MEMORANDUM

Subject: Preliminary Plat – Comet Ridge

DRAWING NO. SHEET 2 OF 2

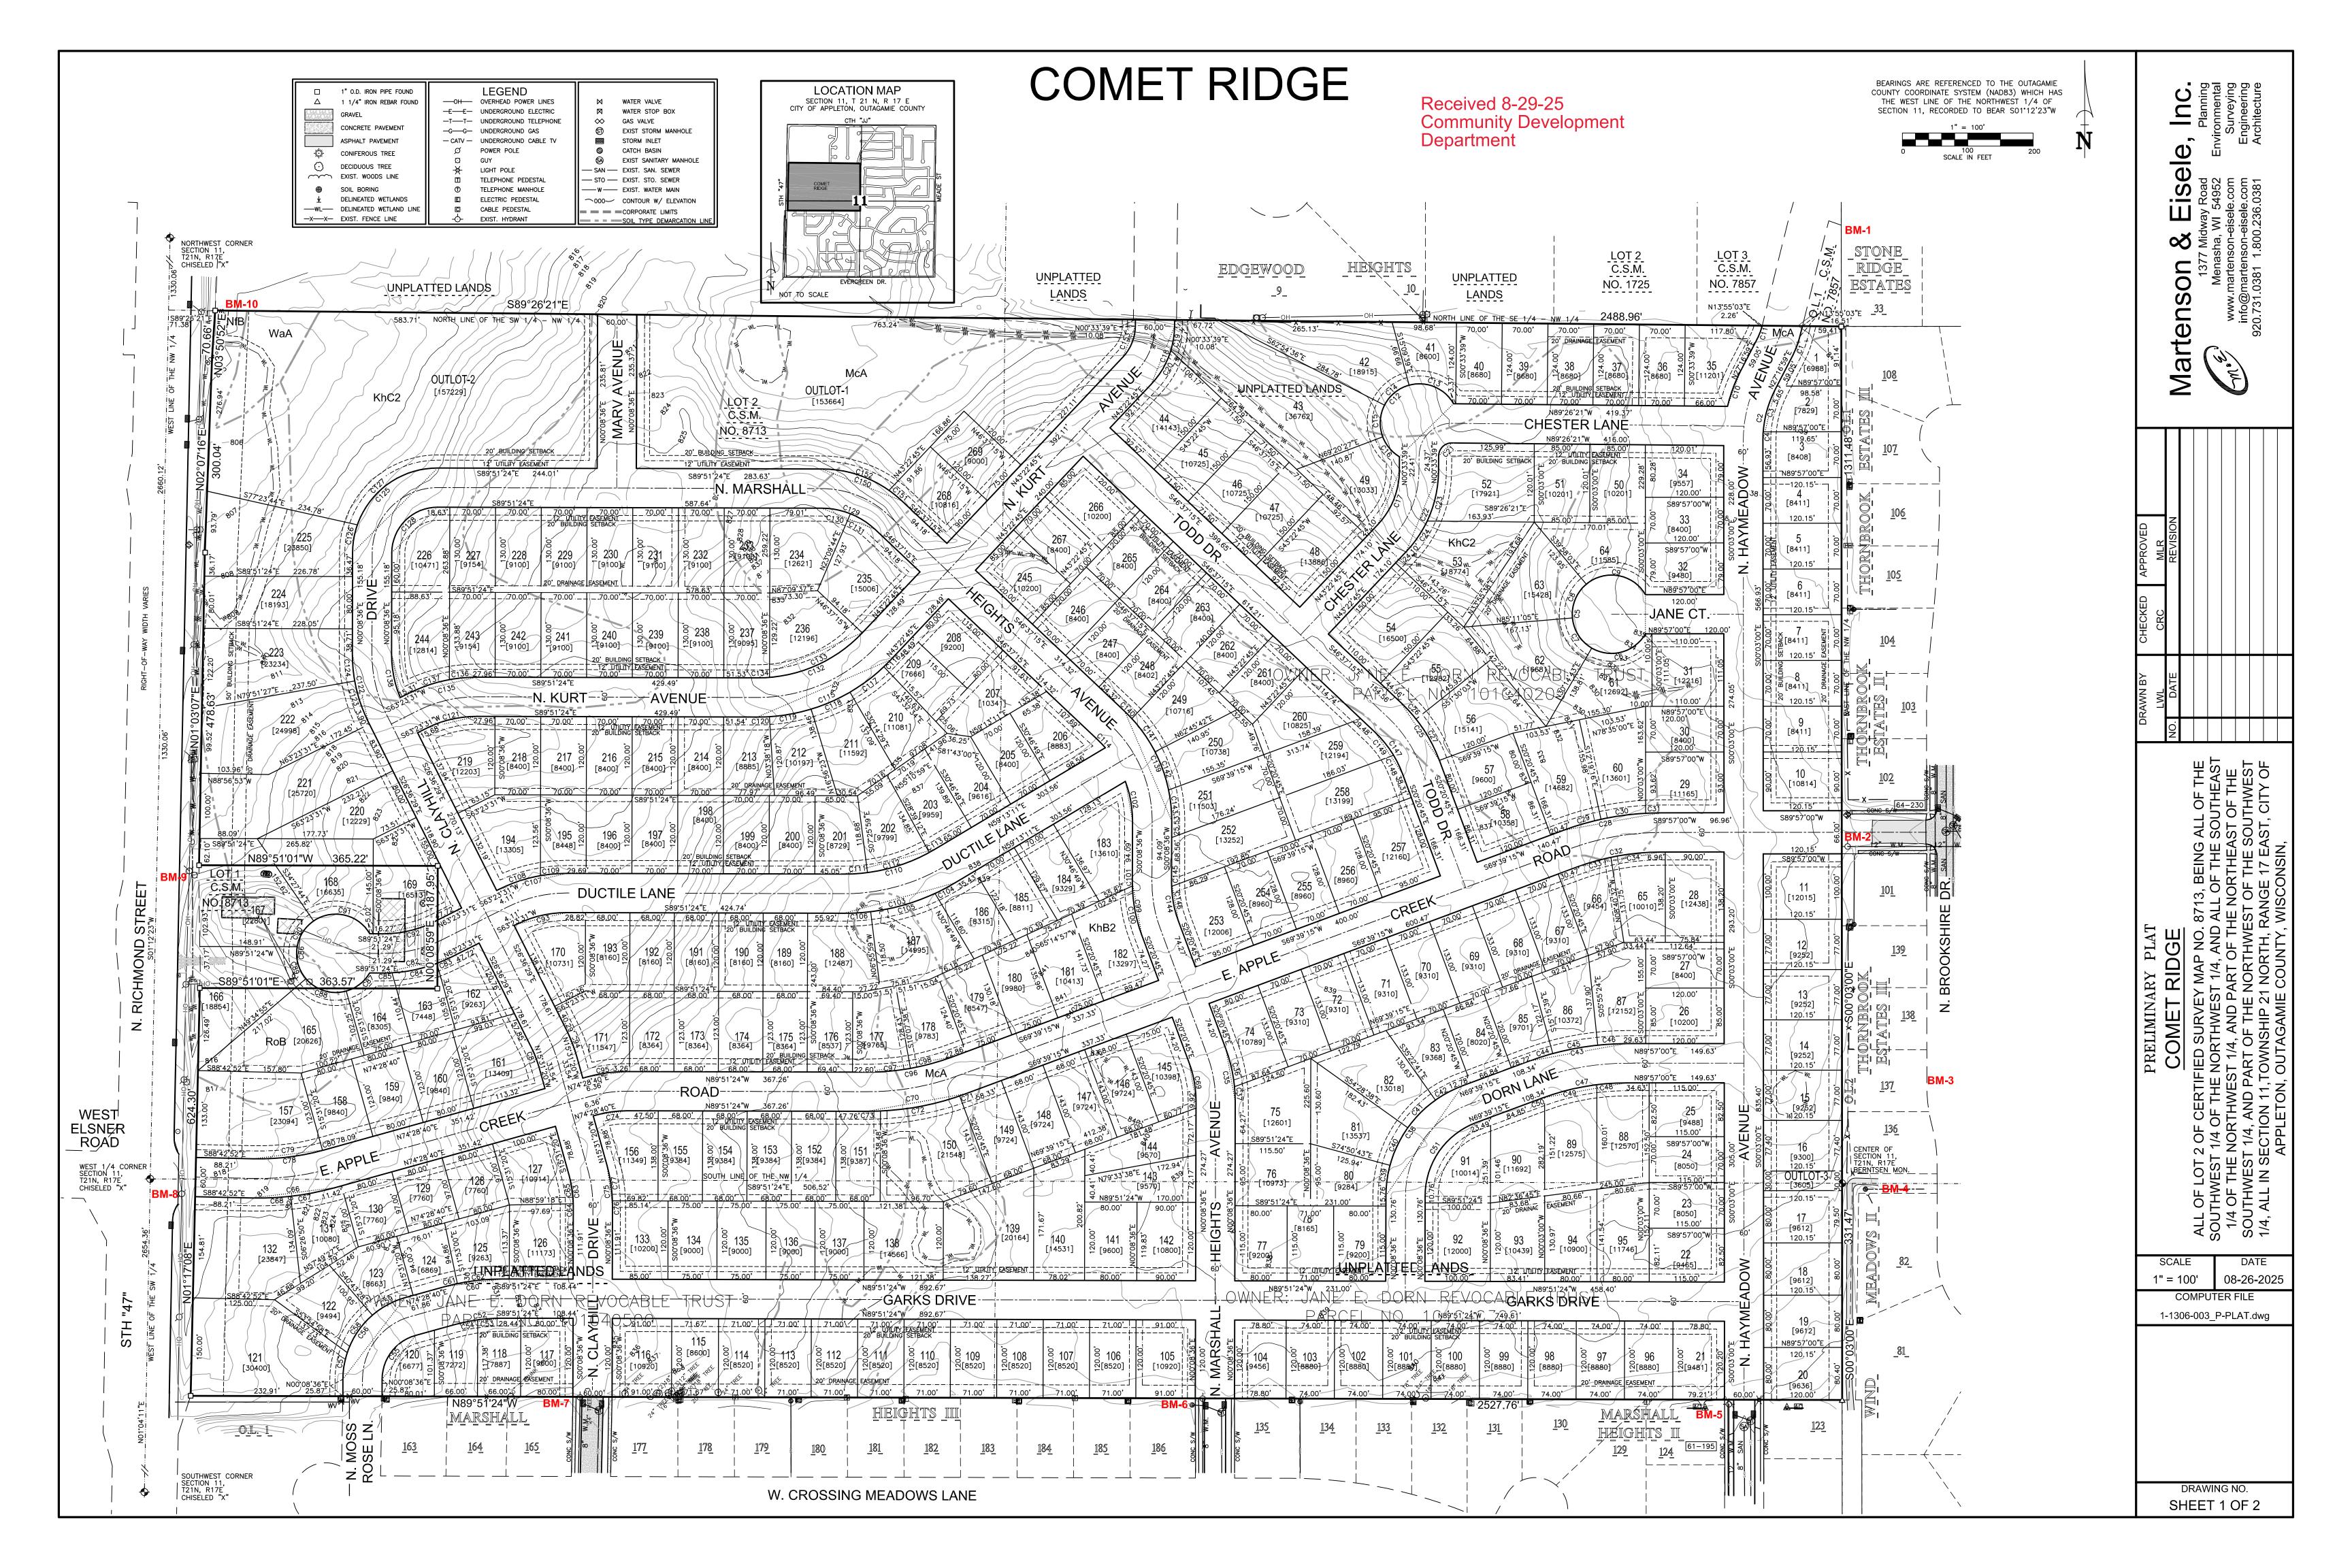
- Minimum lot area: 6,000 square feet.
 - The proposed average lot size within this development is 8,911 square feet. All lots exceed the minimum lot area requirement, except it appears Outlot 3 does not satisfy this requirement.
- Minimum lot width: 50 feet.
 - All lots comply with this minimum requirement, except it appears Outlot 3 does not satisfy this requirement.
- Minimum front, side and rear yard setbacks: Twenty (20) foot front yard, Six (6) foot side yard, and Twenty-five (25) foot rear yard.
 - Required front yard setback has been shown on the Preliminary Plat. Required setbacks will be reviewed through the building permit review process.
- Maximum building height: Thirty-five (35) feet.
 - o This will be reviewed through the building permit review process.
- Maximum lot coverage. Fifty percent (50%).
 - This will be reviewed through the building permit review process.

Section 17-26(g) of the Municipal Code discourages excessive lot depth in relation to width, with a 2:1 depth-to-width ratio considered the maximum for lots 60 feet wide or greater. The proposed double frontage lots, while exceeding this ratio, are being platted with a 50-foot State Highway Building Setback Line. This results in greater lot depth compared to other proposed lots; however, the intent of Section 17-26(g) to promote uniformity, orderly layout, and adequate accessibility is satisfied despite the technical ratio being exceeded.

Outlot 3 does not satisfy the minimum 6,000 square foot lot size and minimum 50 foot lot width requirement of the R-1B Zoning District. Section 17-29(g)(1)c. of the Municipal Code, outlots dedicated for a public trail are exempt from the dimensional standards of the R-1B Zoning District.

Analysis: Lots 121, 221, 222, 223, 224 and 225 are double frontage lots. The creation of double frontage lots cannot be avoided because Richmond Street (STH "47") is governed by Wisconsin Department of Transportation Access Restrictions.

Analysis: The developer has proposed a potential future land division of Lot 43 to address a double frontage issue. Relocating the agricultural wetland ditch is necessary to divide Lot 43 into two lots. If a permit is approved by the Wisconsin Department of Natural Resources or Army Corps to relocate the agricultural wetland ditch, the developer will reconfigure this lot with the next phase of Comet Ridge Development. At this time, we will withhold any recommendation to grant a waiver for Lot 43 until additional information becomes available regarding the proposed ditch relocation.

- Ductile Lane west of Clayhill Drive will need to change to Ductile Court.
- The street name Jane Court exists in Winnebago County. To avoid confusion for 911 emergency service calls, a new street name for this court will need to be proposed.
- The street name Garks Drive could cause confusion 911 emergency service calls, a new street name for this court will need to be proposed.

- 1. Grant relief from the double frontage lot requirements for proposed Lots 121, 221, 222, 223, 224 and 225 per Section 17-26(c)(2) of the Municipal Code and as stated in the staff report.

- 2. Identify Outlot 3 being dedicated to the public for public trail purpose, add a note on the final plat "Dedicated to the public for public trail".
